# Jackson Hole, Wyoming Environmental Restoration Draft Feasibility Study

Draft Feasibility Study  
and  
Environmental Assessment  
Comment Response Package  
Environmental Assessment  
Finding of No Significant Impact  
Monitoring Plan

April 2000

**Figure 6-1. All Four Areas - Fish Habitat Unit Projections.**

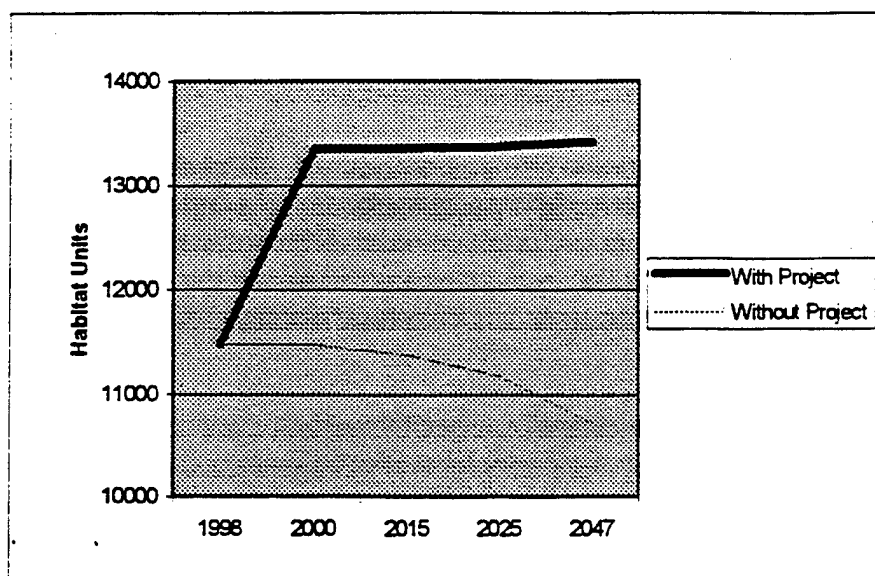
18 6.2.1.1 Cutthroat Trout (Habitat Quantity and Quality Assessment) -- How the assessment of habitat units (with and without project) was determined is unclear. Though the relationships shown in Figure 6-1 may be accurate for a given site, the benefit of this project to the Snake River system as a whole will be negligible and should be noted. Also, unless there is a high level of maintenance on these created habitats, they too will degrade over time.

Comment 18: Figure 6-1 represents a combined estimate of fish habitat unit projections for the four restoration areas and, therefore, is not intended to represent any single site. The Corps recognizes that each site is different and that the quantity and quality of fish habitat that may be restored will vary from site to site. The Corps also recognizes there are numerous areas along the Snake River that could benefit from restoration efforts and that any benefits derived from restoration in the four areas would be a small portion of any overall potential benefits. Monitoring would be used to assess the level of maintenance necessary for the various tools.
